Wisconsin Department of Transportation

Proposal #01: 3080-01-40, N/A
Madison - Cambridge
CTH AB Overpass
USH 12
Dane County

3080-01-76, WISC 2022451
Madison - Cambridge
CTH AB Interchange
USH 12
Dane County

This is Addendum No. 01, which provides for the following:

Addendum No. 01
 ID 3080-01-76
 Revised Sheet 42
 June 28, 2022

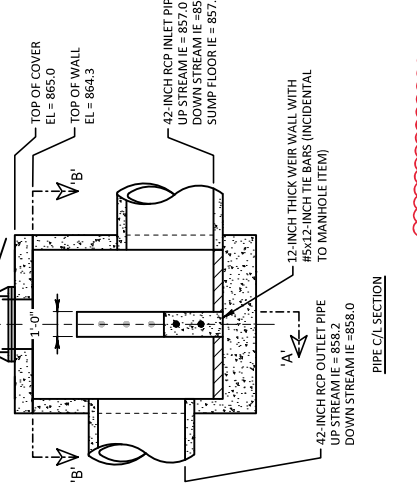
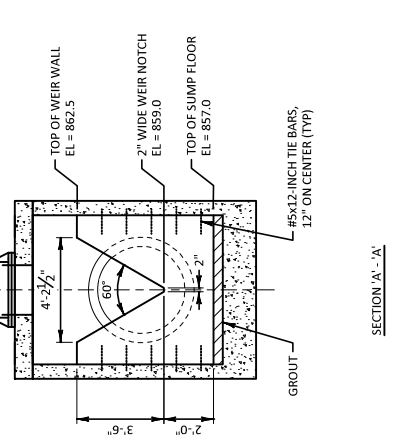
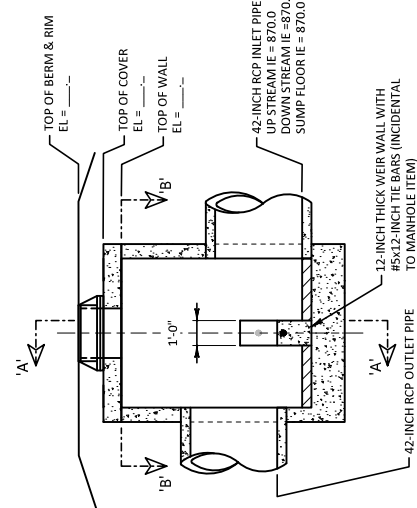
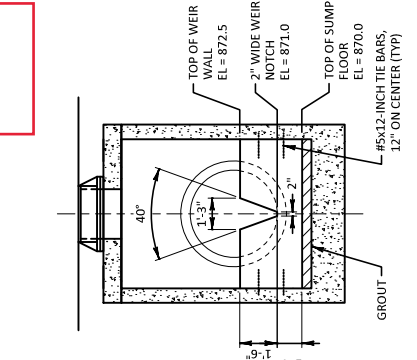
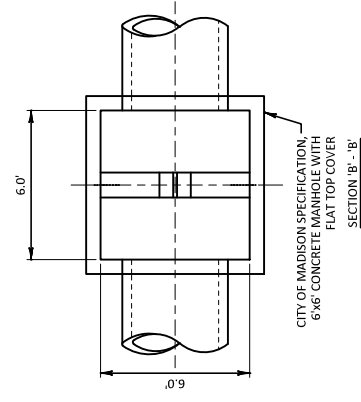
Revised Plan Sheets	
Plan Sheet	Plan Sheet Title (brief description of changes to sheet)
34	Construction Detail-Millpond Infield-Optional Waste Site (increased top slope along alignment from 1% to 2%)
42	Drainage Pond Detail (revised item name callouts)
43	Drainage Pond Detail (revised item name callout)
44	Drainage Pond Detail (revised item name callout)
80	Removal Plan (revised removing fence limits)
190	Storm Sewer: CTH AB/Millpond Road (revised SS pipe & AEW materials)
191	Storm Sewer: CTH AB (revised SS pipe & AEW materials)
192	Storm Sewer: CTH AB (revised SS pipe & AEW materials)
196	Storm Sewer: CTH AB (revised SS pipe & AEW materials)
197	Storm Sewer: CTH AB (revised SS pipe & AEW materials)
307	Pavement Marking (added Marking Diagonal Epoxy 12-inch to Millpond Road)
474	Miscellaneous Quantities (switched bid item for culvert pipes)
477	Miscellaneous Quantities (switched bid items for SS pipes)

Addendum No. 01
 ID 3080-01-75
 Revised Sheet 1325
 June 28, 2022

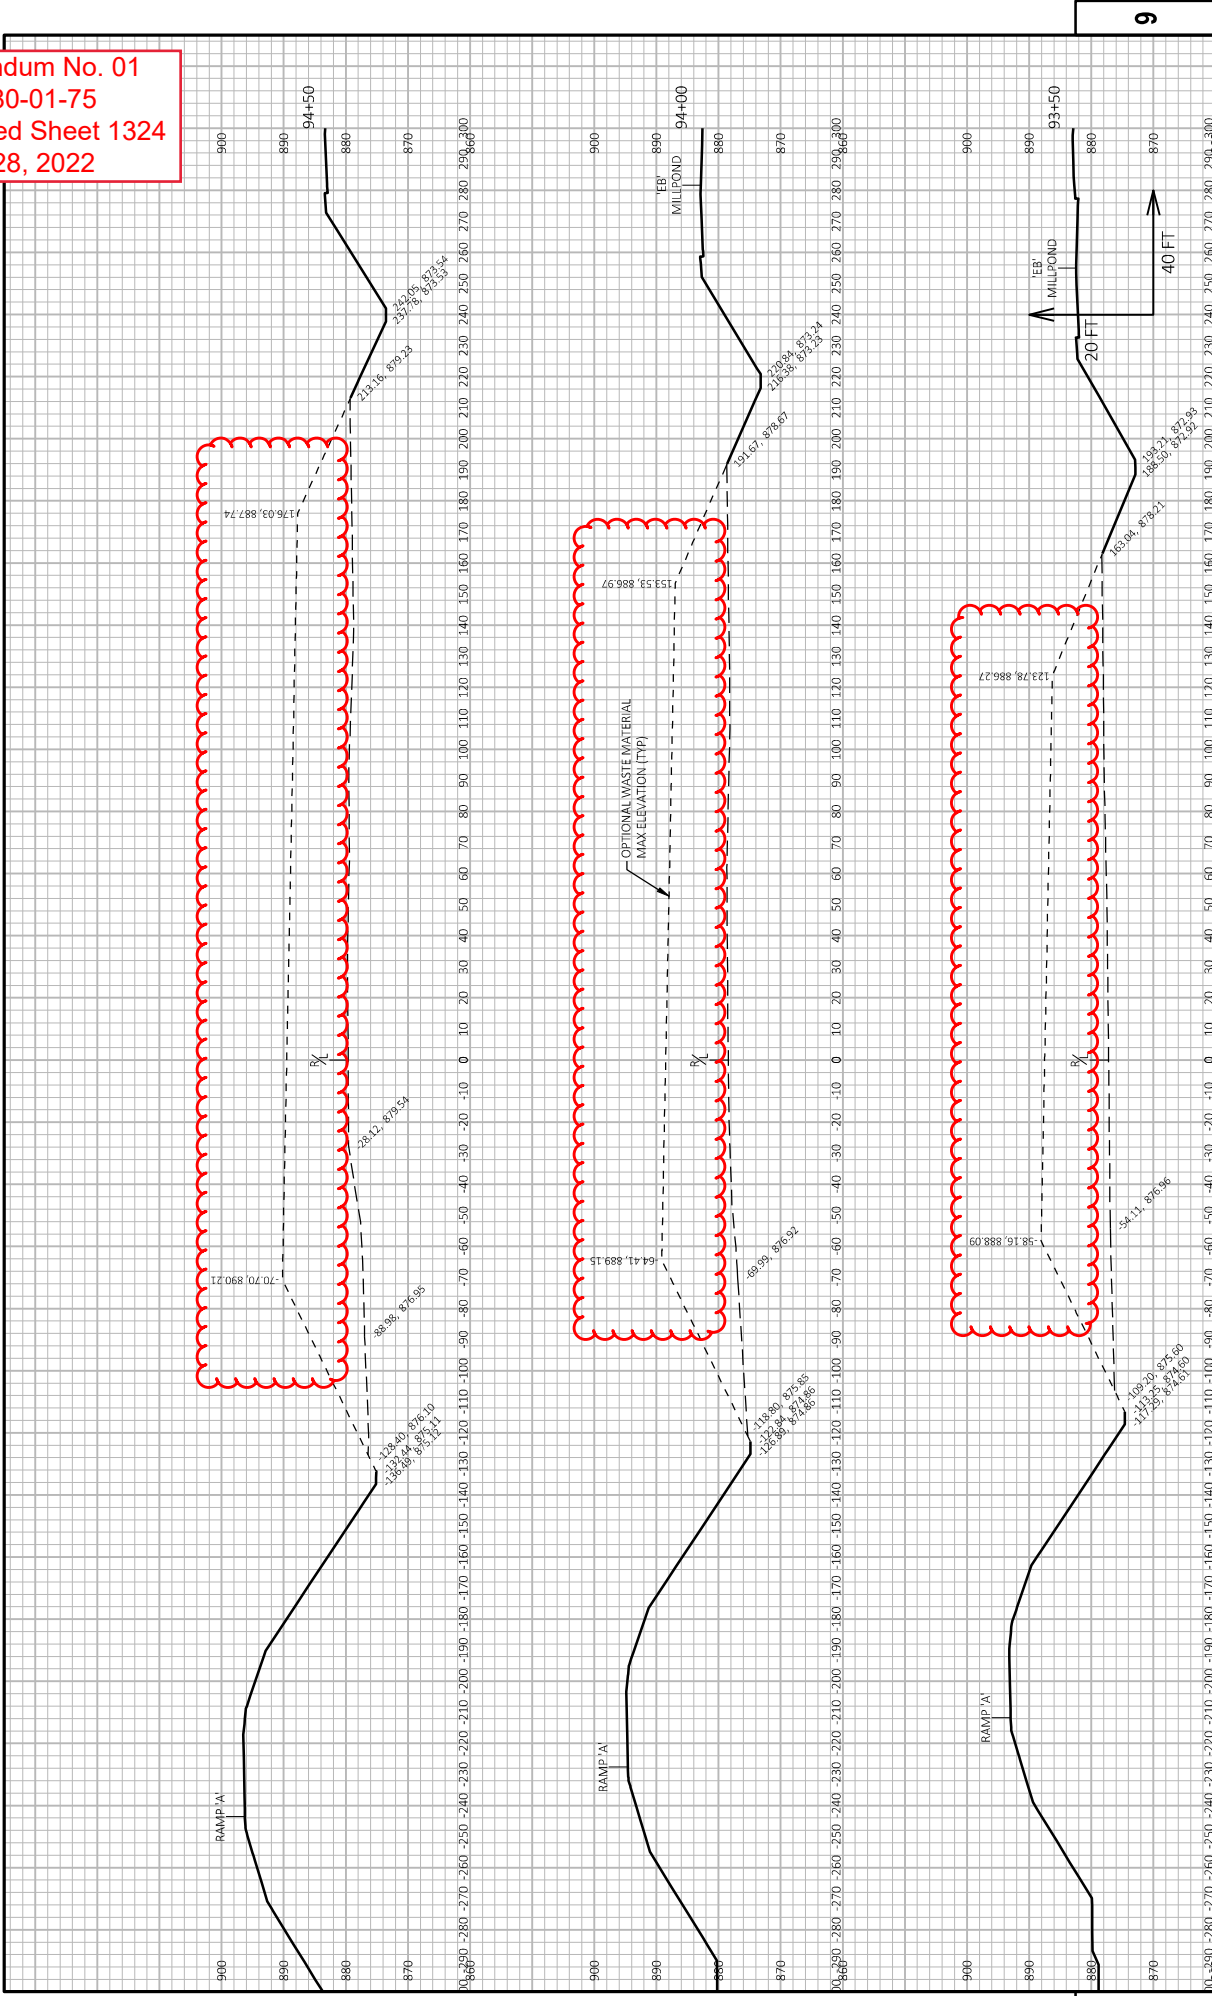
478	Miscellaneous Quantities (switched bid items for SS pipes)
479	Miscellaneous Quantities (switched bid items for SS AEWs)
481	Miscellaneous Quantities (switched bid items for SS AEWs)
493	Miscellaneous Quantities (revised table for removing fence/gate)
509	Miscellaneous Quantities (switched bid item for culvert pipes)
515	Miscellaneous Quantities (revised item names in Pond A and Pond B drainage tables)
548	Miscellaneous Quantities (revised quantity for Marking Diagonal Epoxy 12-inch)
585	Plan and Profile: CTH AB – 'NB' (revised culvert pipe material)
588	Plan and Profile: CTH AB – 'SB' (revised culvert pipe material)
599	Plan and Profile: Millpond Road (added culvert callout in profile)
1323	Cross Sections: Millpond Infield (revised elevations for top of waste site)
1324	Cross Sections: Millpond Infield (revised elevations for top of waste site)
1325	Cross Sections: Millpond Infield (revised elevations for top of waste site)

Addendum No. 01
 ID 3080-01-75
 Revised Sheet 1326
 June 28, 2022

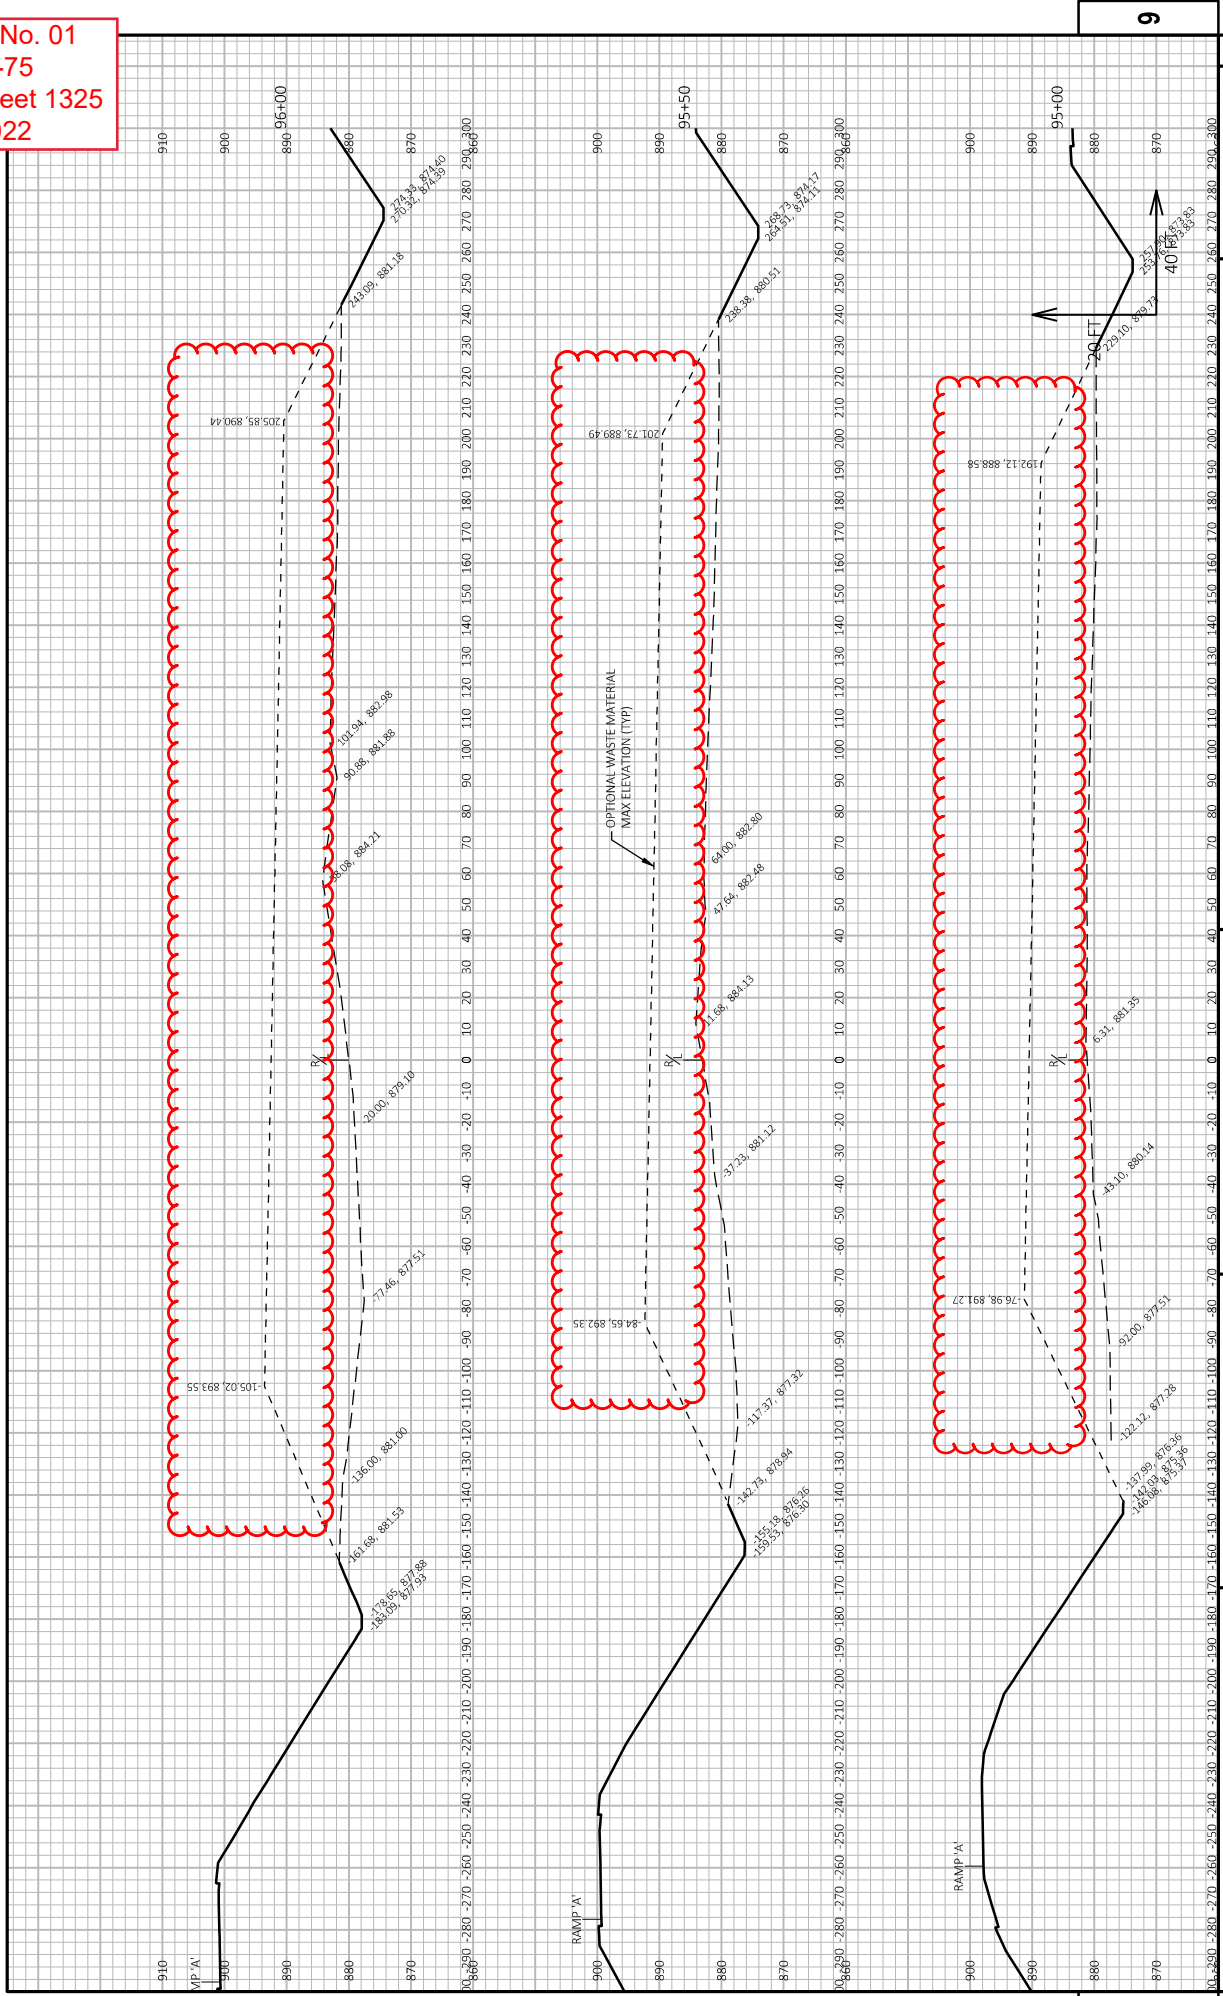
1326	Cross Sections: Millpond Infield (revised elevations for top of waste site)
1327	Cross Sections: Millpond Infield (revised elevations for top of waste site)
